## 2.6 Nuclear Steam Generation System

The HTR two-module plant is designed as a double-block facility with two reactors, each with 200 MW thermal capacities. Therefore, two nuclear steam generating systems, each independent of the other, have been provided and share some auxiliary installations.

Figure 2.6.1: HTR pressure vessel unit (RDB+DE+connecting pressure vessel) under internal pressure

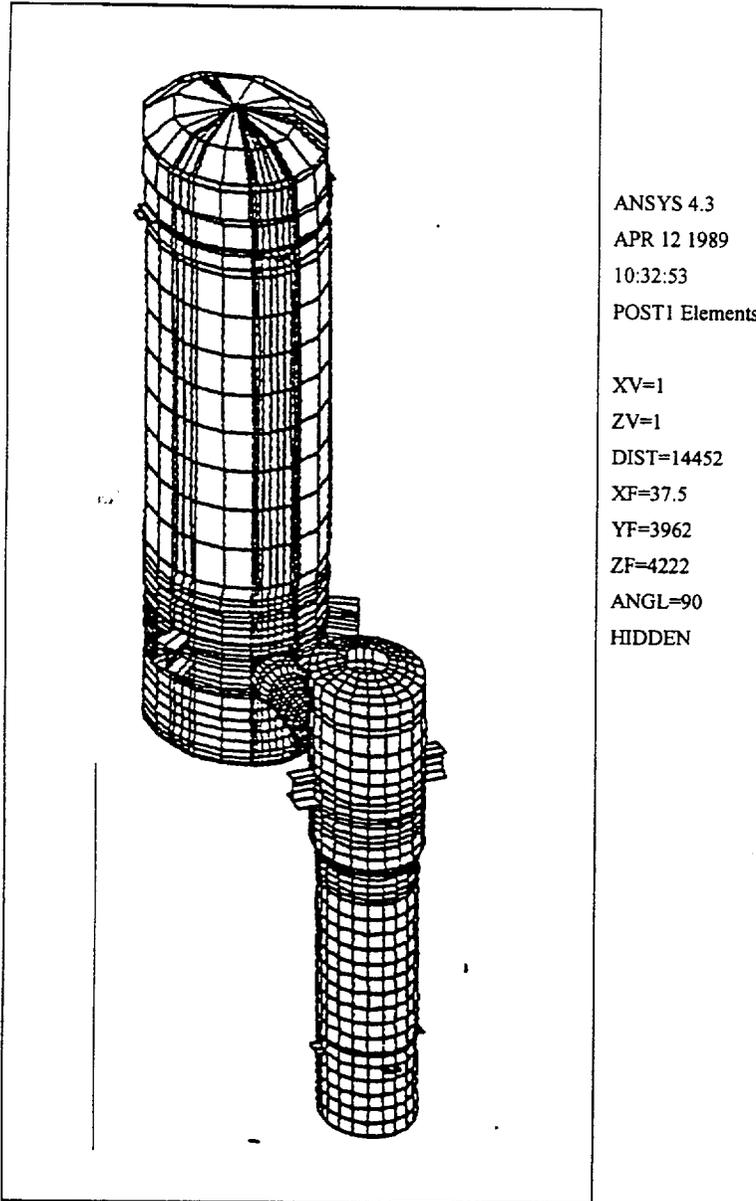
Within the framework of the design phase, no analysis of the mechanical behavior according to KTA Rule 3201.2 was carried out by the applicant. However, to evaluate the mutual influence of temperature, pressure and obstructed thermal expansion on different vessel units, we have designed the entire pressure vessel unit as a finite element model and calculated the various load types (Figure 2.6-1).
